Statutory Review Design Response

Morland Gardens, London Borough of Brent

Following the receipt of comments from GLA, TFL & Brent Highways on the submitted scheme for Morland Gardens, this document has been produced in order to respond to those comments and show how the scheme has been amended.

1.
Greater London Authority - GLA/5444/01 - 09.03.2020
(GLA Comments)
2.
Transport For London - BRNT/20/7 - 20.03.2020
(TFL Comments)
3.
LBB Highways - D91/1324EP/1 - 25.03.2020
(LBB Highways Comments)

Affordable Workspace units at Lower Ground floor

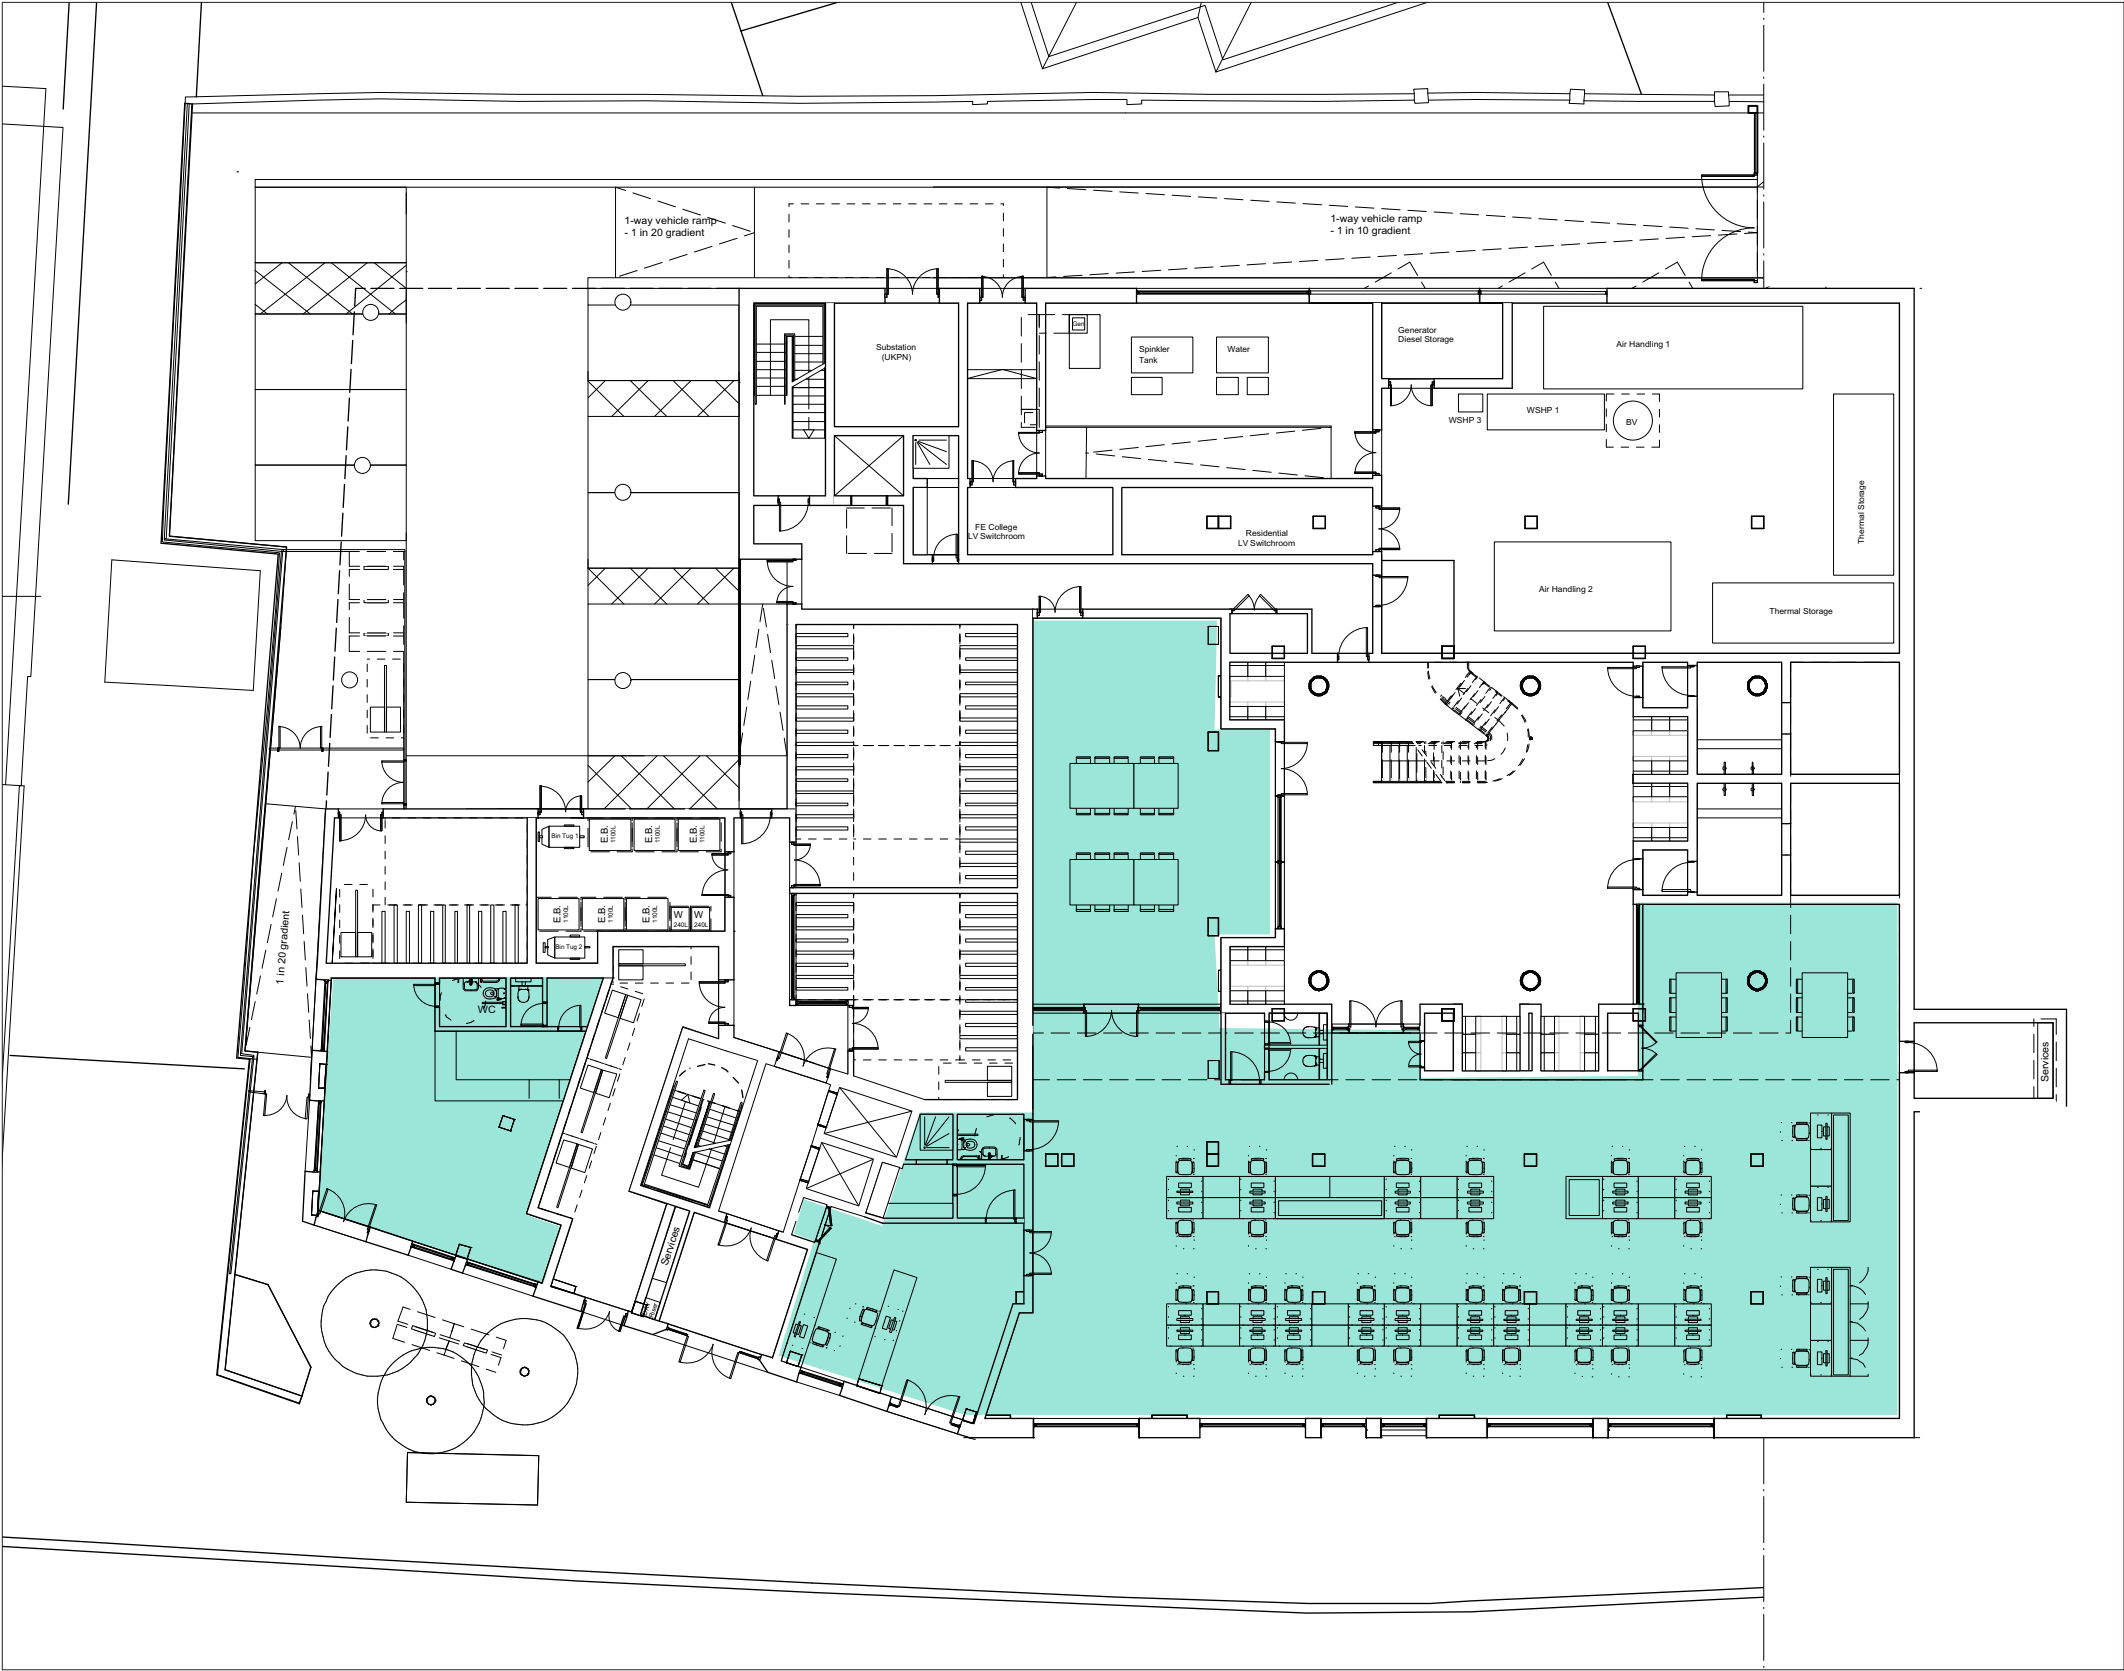
‘20 The Mayor’s Intend to Publish London Plan Policy E3 sets out defined circumstances for the provision of affordable workspace, which is let at sub-market levels. The policy states that such workspace should serve a specific social, cultural and economic development purpose. Furthermore, affordable workspace should be provided in areas identified in a local Development Plan Document where cost pressures could lead to the loss of affordable workspace or where such workspace would sustain a mix of business or cultural uses which contribute to the character of an area.

21 There would be a clear synergy between the re-provision of the further education college, which would continue to run a variety of vocational courses, and the provision of affordable workspace. However, whilst this benefit is supported, the applicant has not provided any information on the affordable workspace in terms of planning policy. The applicant should clarify which sectors the affordable workspace is intended to support and how it addresses identified cost pressures or sustains a mix of business or cultural needs, with reference to the adopted and draft Brent Local Plan, the London Plan and the Mayor’s Intend to Publish London Plan. The rent levels and management arrangements for the affordable workspace should be secured within the S106 agreement.’

This matter is for LBB as client to pursue. However, it is seen that this matter can be dealt with during Section 106 negotiations and need not inhibit the determination of the application.

Unit 02-08

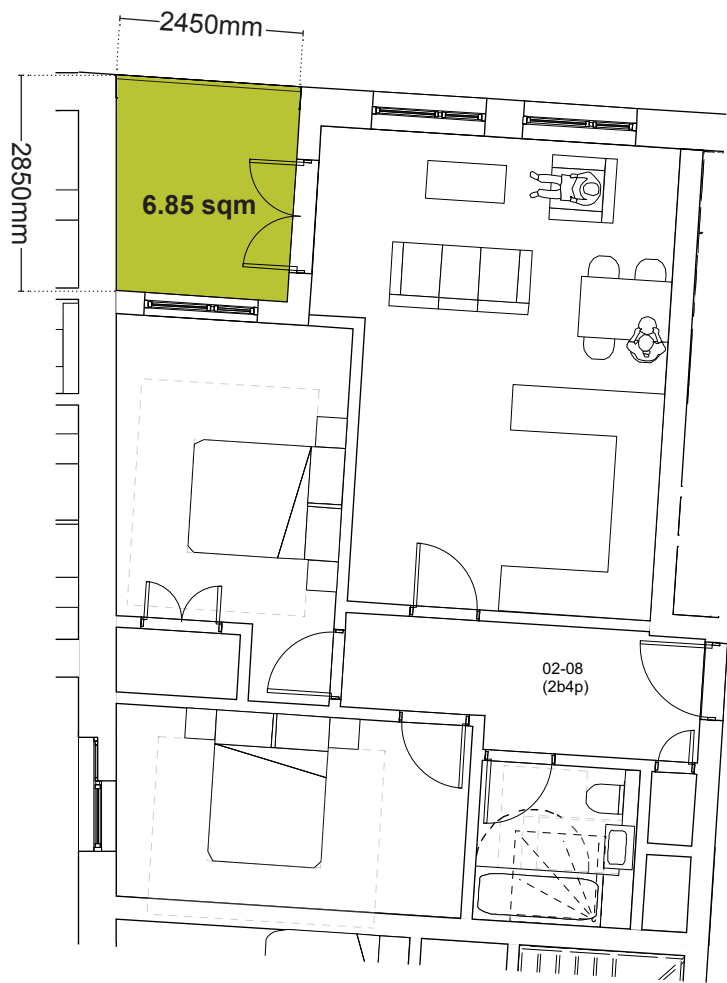
‘Most of the units would meet or exceed the private amenity space requirements. Unit 02-08 has 0.5 sq.m. and unit 03-04 has 1.8 sq.m. less private amenity space than required; the applicant should increase the provision of this amenity space’

Similarly, Unit 02-08 is incorrectly represented as having 6.5sqm when in fact the figure is 6.85 sqm. We note the shortfall of 0.15sqm here but would add that the flat also has access to generous shared amenity areas both via the Resident’s Garden at Level 1 and to the communal terrace serving the East block at Level 6. These total 814sqm. We note also that the amenity space provided would have a pleasant outlook down Morland Gardens.

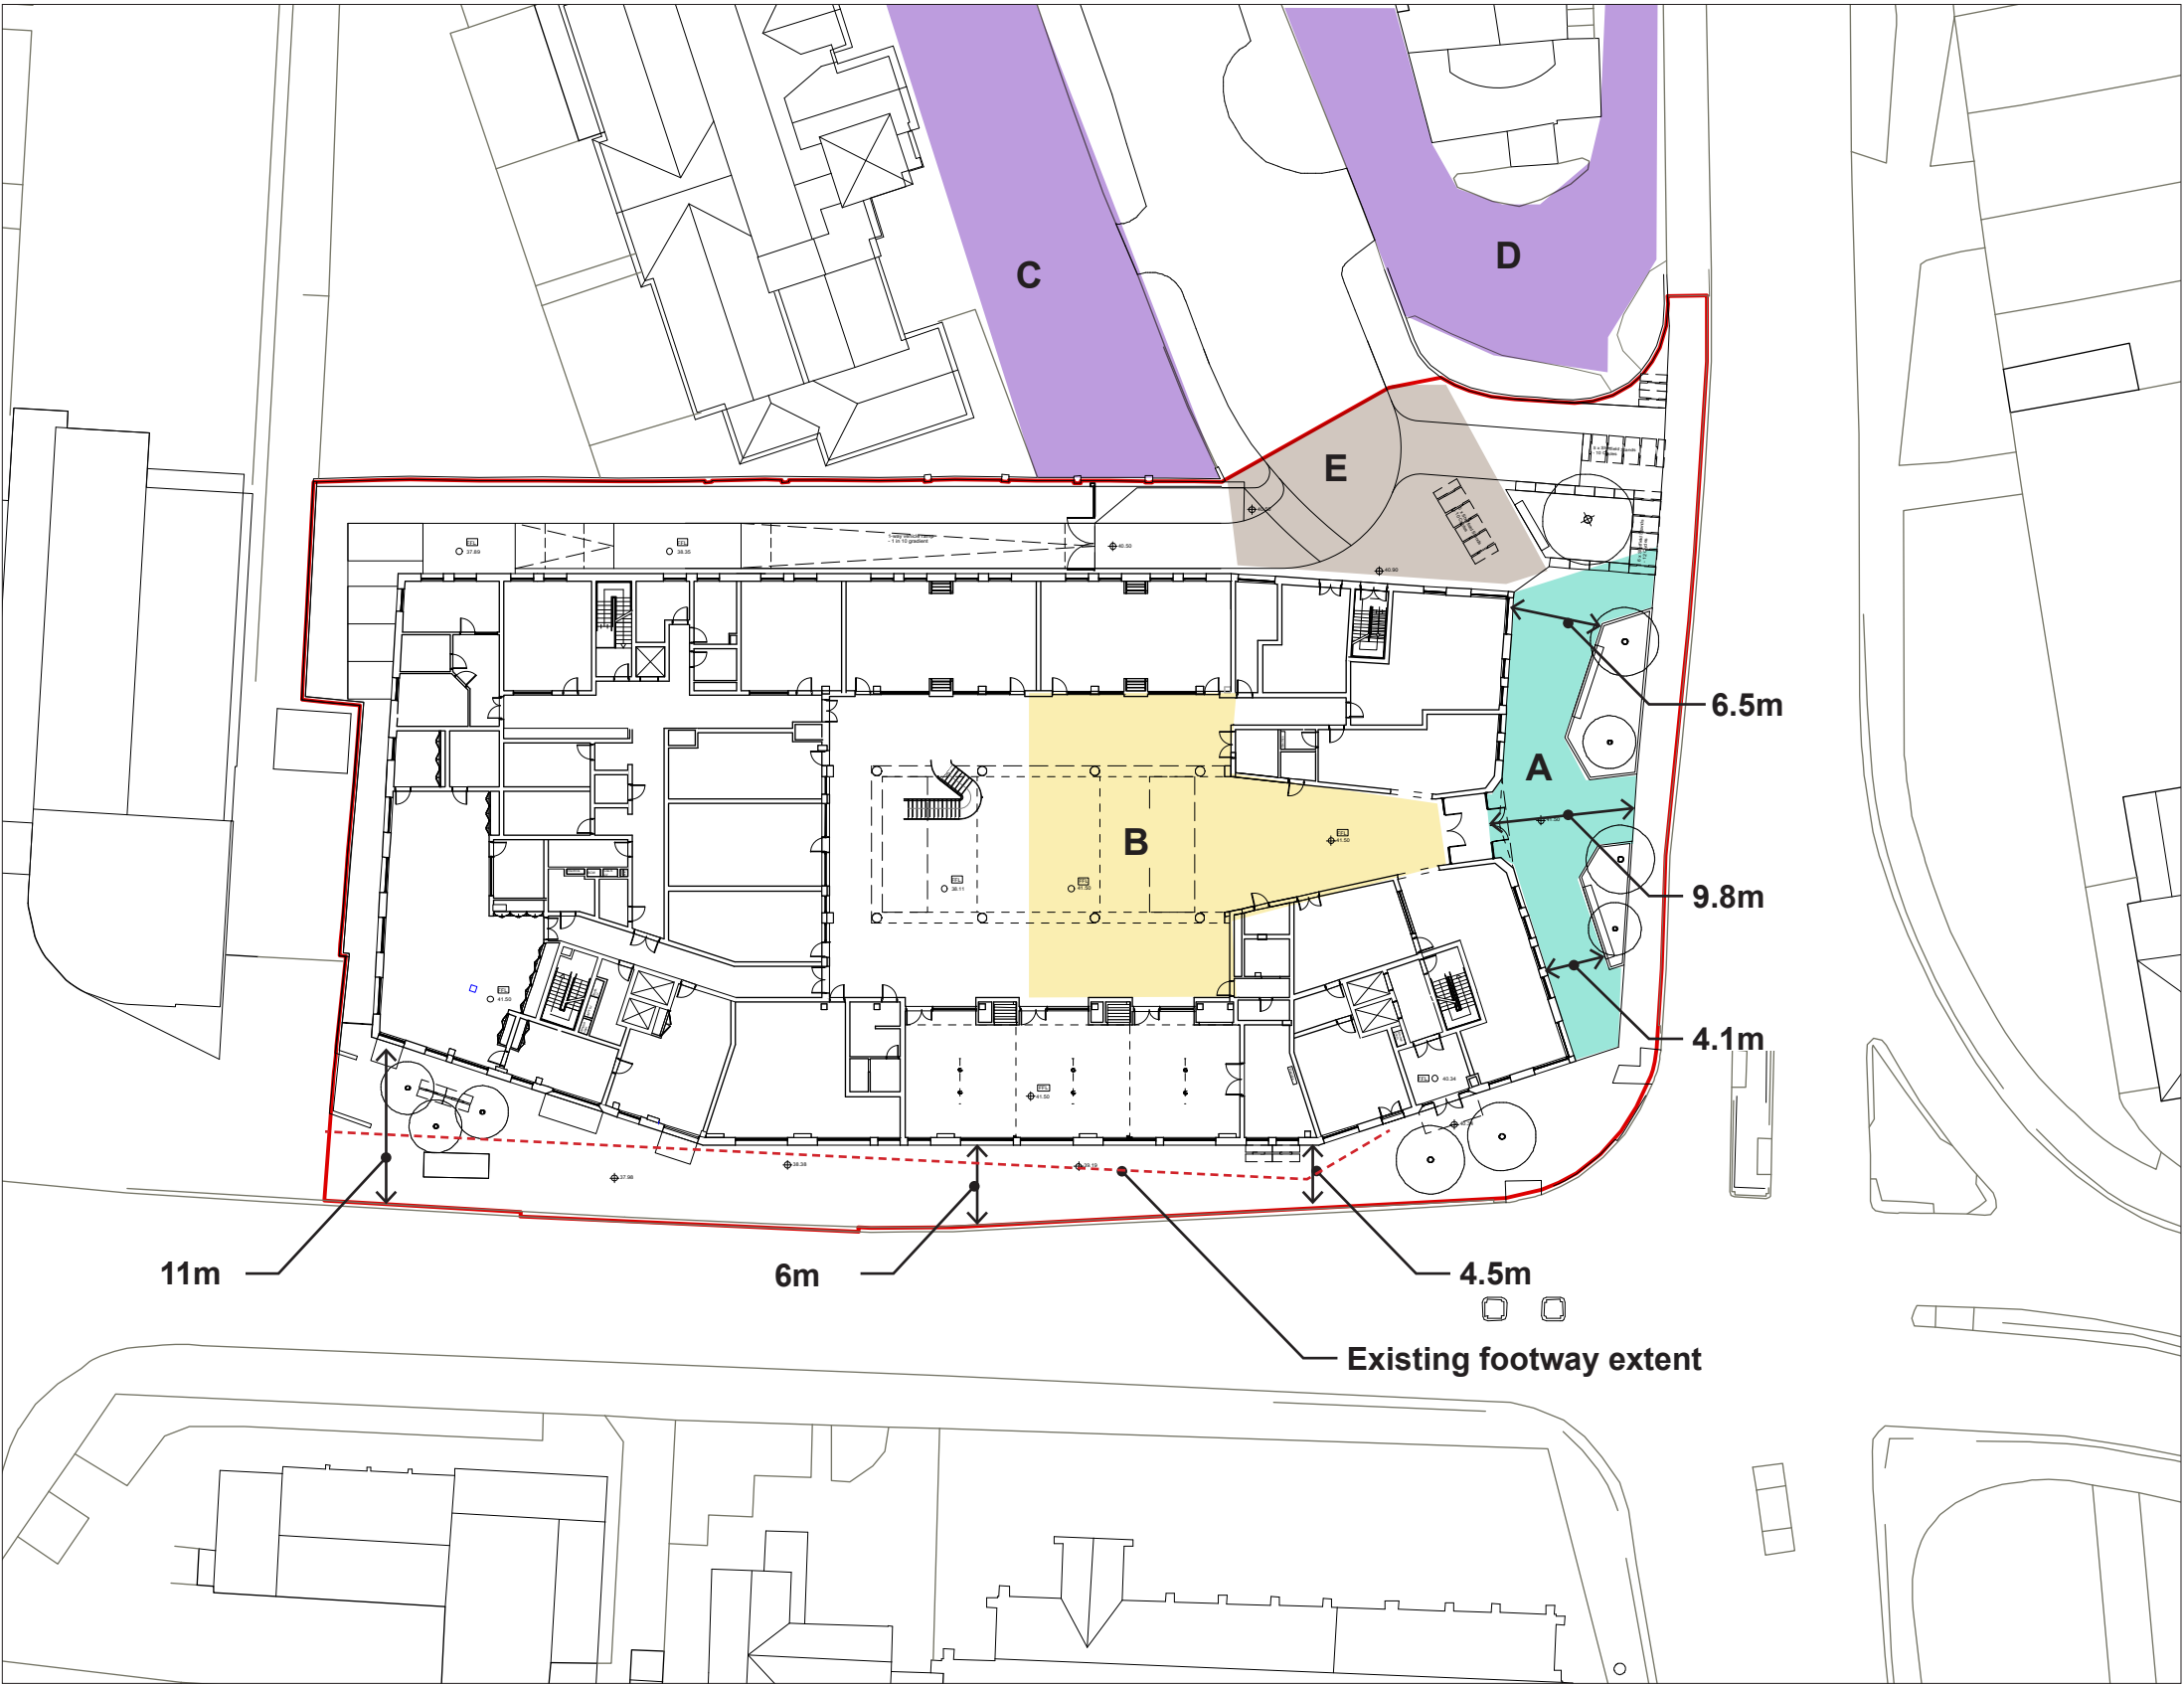
‘The applicant should clarify how many students would be using the college and demonstrate that the public realm in this area is sufficient to allow for the safe entry, egress and emergency assembly of students from the development.’

The area of paved open public space directly adjacent to the main entrance (Area A) is 185 sqm. At the entrance this area is 10m deep but varies elsewhere between 6.5 and 4m to accomodate a pair of refurbished planted beds. Existing trees are in poor condition and will be replaced by large canopy mature trees.

Within the building a large unobstructed Lobby flows onto the central multifunctional space which is 350sqm. As such there is also plenty of space for users of the building to disperse into.

It should also be noted that the pavement widths on Hillside have substantially increased from their current condition (note the dotted line opposite)

In addition two larger areas which are safe for assembly in the event of a fire or a requirement for emergency egress are available nearby. (Areas C & D). It should also be noted that Morland Gardens (Area E) is a ‘dead end’ offering a sheltered zone in the event of emergency.

Figure 8 – Noise Sensitive Receivers and Proposed Rooftop Plant Area

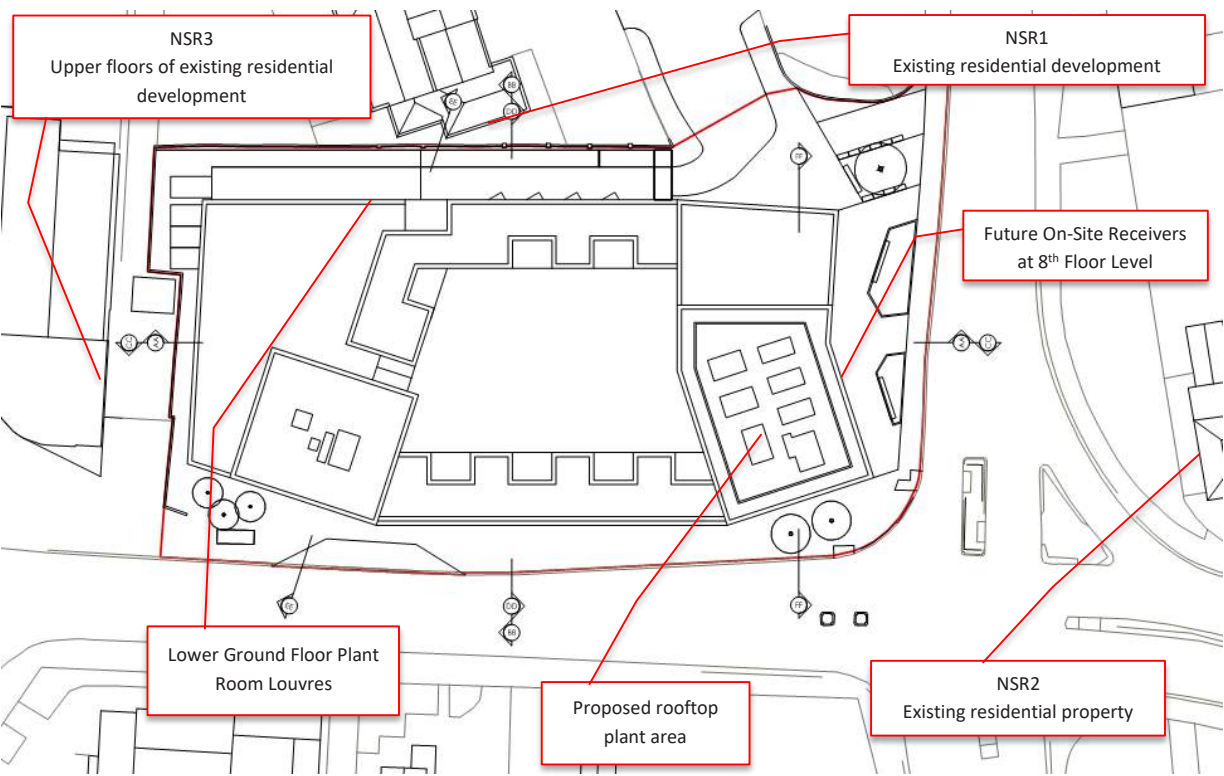
33 The submitted noise assessment only considers the impact of noise on the development; the applicant should consider the impacts of noise from the development on neighbouring and on site residential uses and propose appropriate mitigation measures.’

Based on the footprint of the proposed development, the nearest on and off-site noise sensitive receptors (NSRs) have been identified and indicated in Figure 8.

Current proposals indicate 3 No. ASHPs and 1 No. dry air cooler will be located at rooftop level (plant model selections not currently available). To control noise emissions to the identified on and off-site sensitive receivers, an acoustic barrier should be installed. A detailed assessment will be required at a later stage upon final plant selection and provision of detailed manufacturer plant data.

The acoustic barrier shall be 3m high with the internal surface lined with an absorbent lining. The acoustic panels that make up the barrier shall comprise 100mm thick mineral wool packed to a density of not less than 45kg/m³ with a glass fibre tissue facing and retained between a galvanised mild steel sheet. The galvanised steel sheet shall be perforated on the plant side with a free area of at least 25%. The barrier shall have a minimum superficial mass of at least 15kg/m².
